**ADDENDUM #1**  
**400-RFQ 1301**  
**#1 NATURAL RESOURCES COMPLEX BUILDING**  
**EXPANSION AND REMODEL**  
**For**  
**ARKANSAS STATE PLANT BOARD**

Date: **February 4, 2013**

Solicitation Number: **400-RFQ-1301**

Agency Name: **Arkansas State Plant Board**

**FLOOR PLAN**

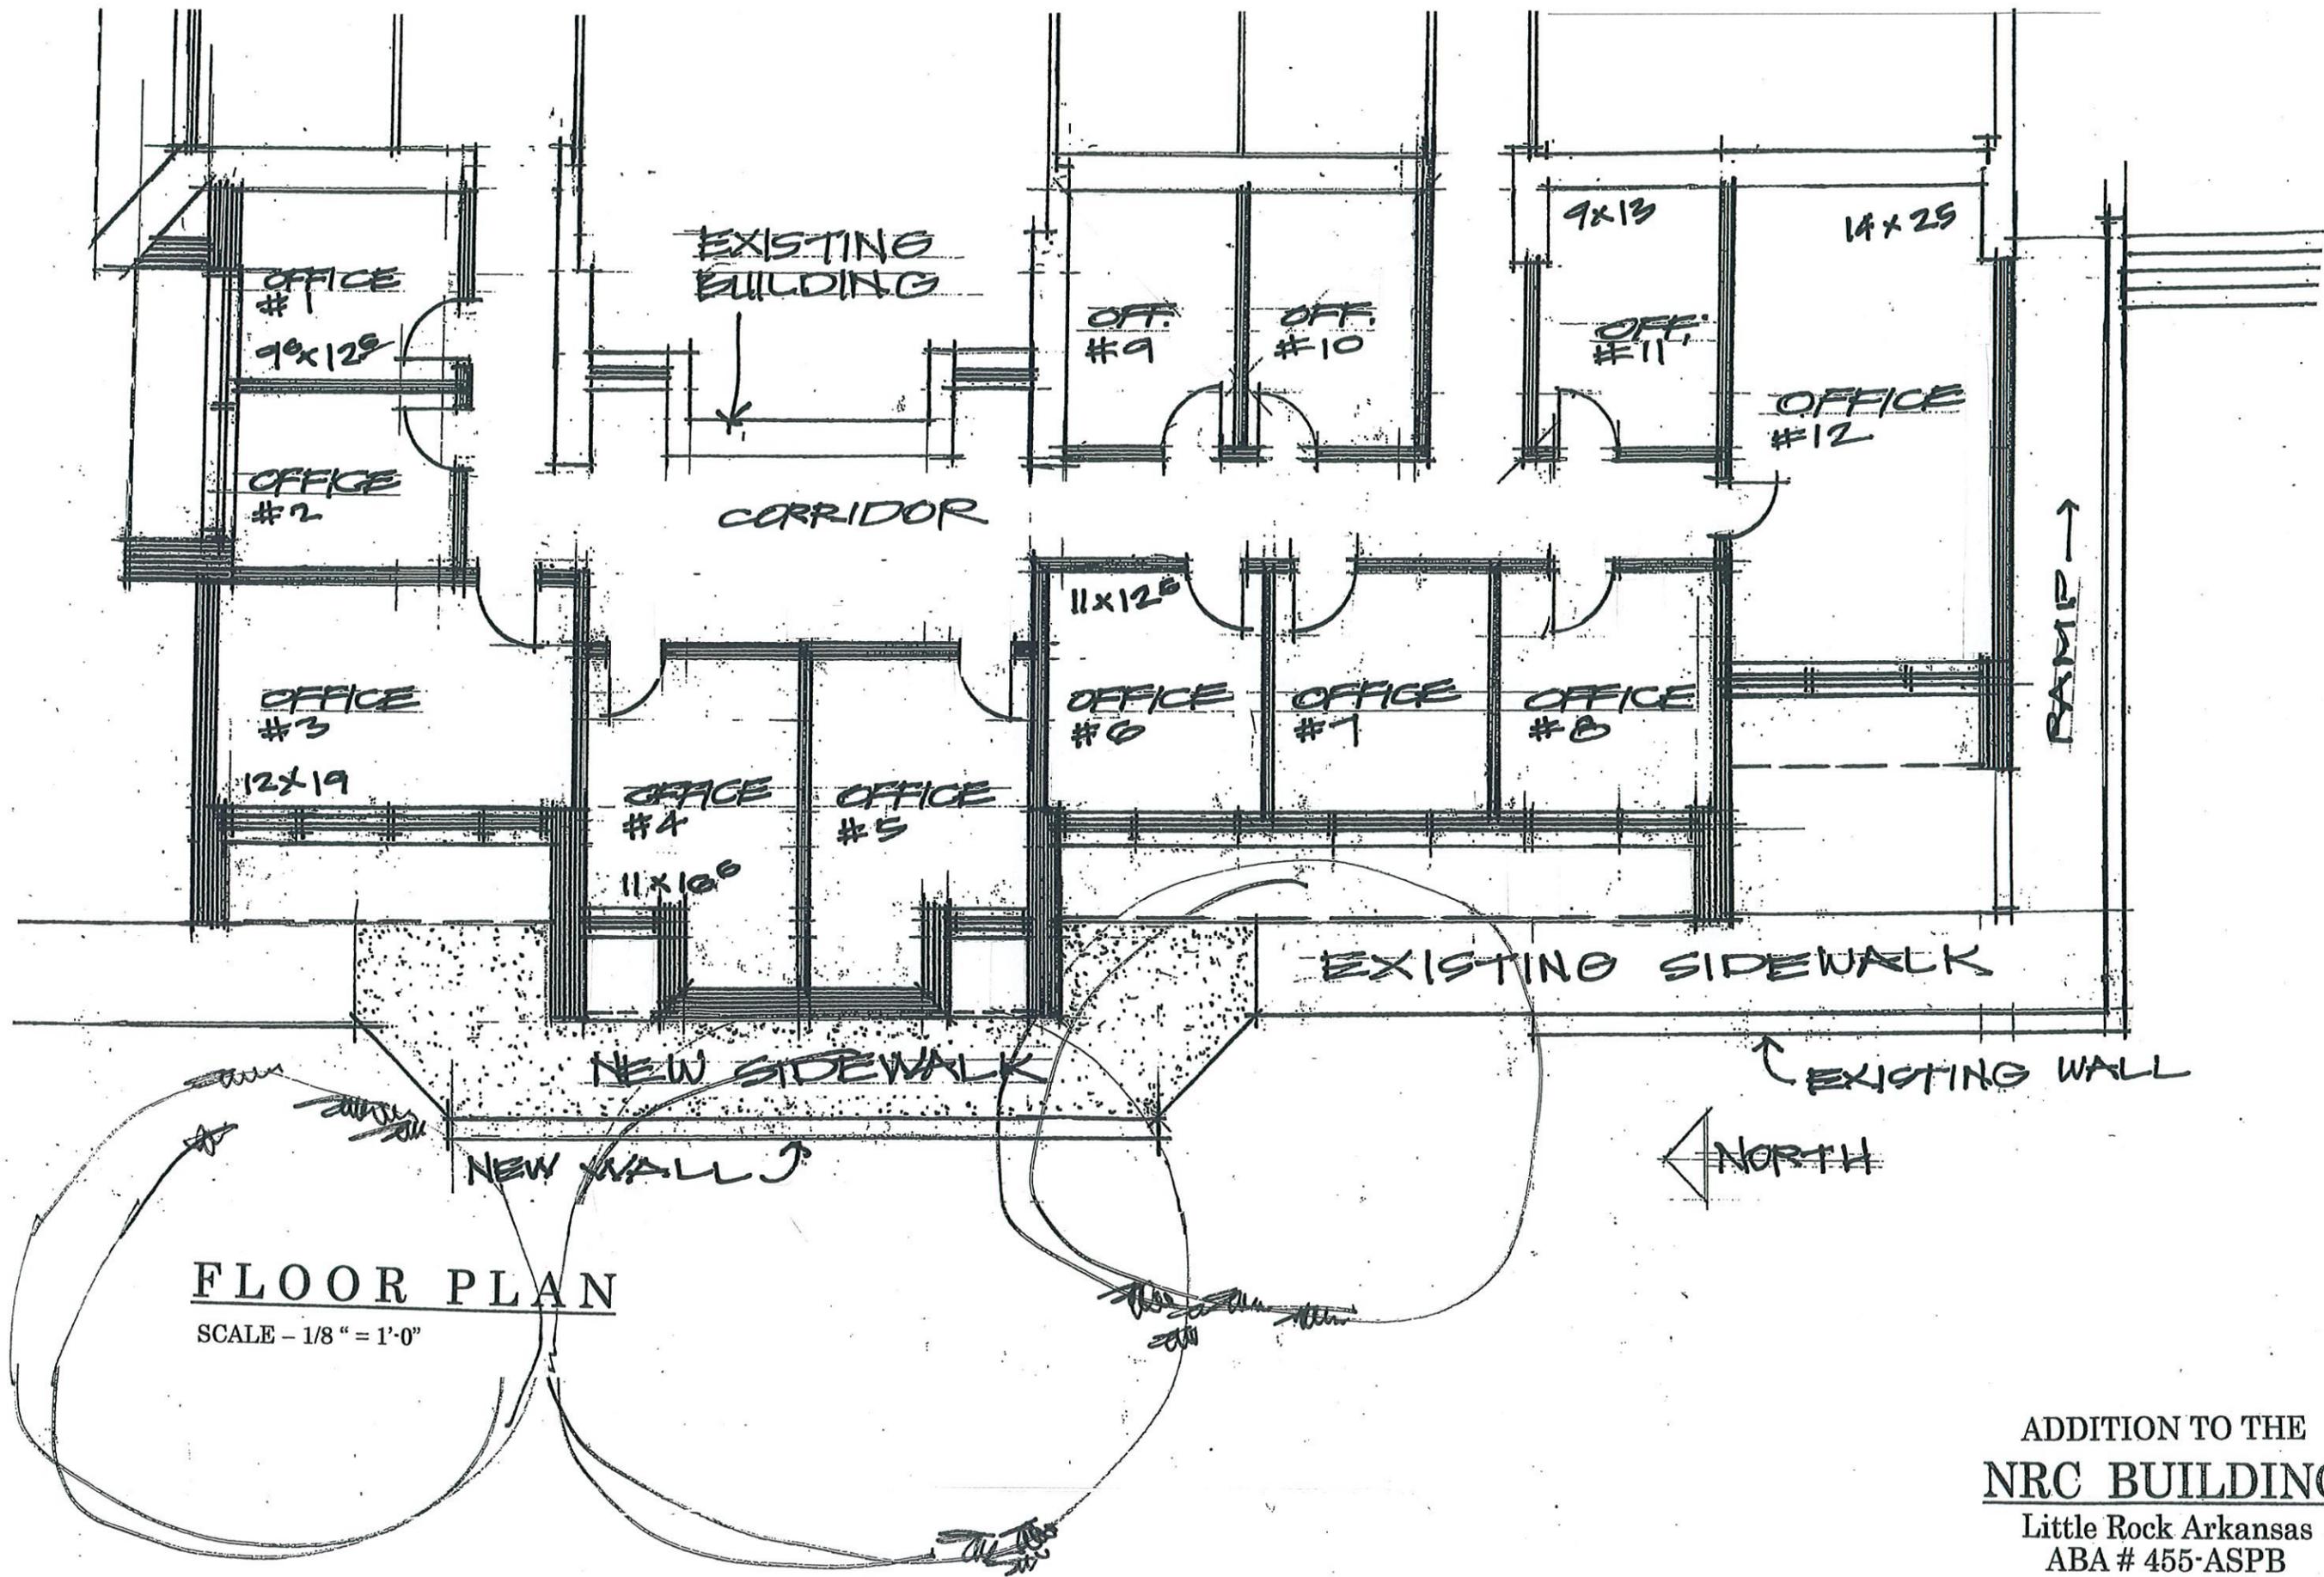
4. **Question:** Can I obtain a copy of the concept drawings prepared by ABA for this addition?

**Answer:** Yes, a copy of the concept plan and elevation are attached to this addendum. Please be advised that these drawings are not intended to show the final design solution for this project. These drawings were prepared to show one possible design solution and to communicate the intended direction of the expansion for the Board’s consideration in approving this project to move forward. The final configuration, style, and design of the addition will be based on the design professional’s recommendations and as approved by the Agency and as required to meet the Agency’s final budget for this project.
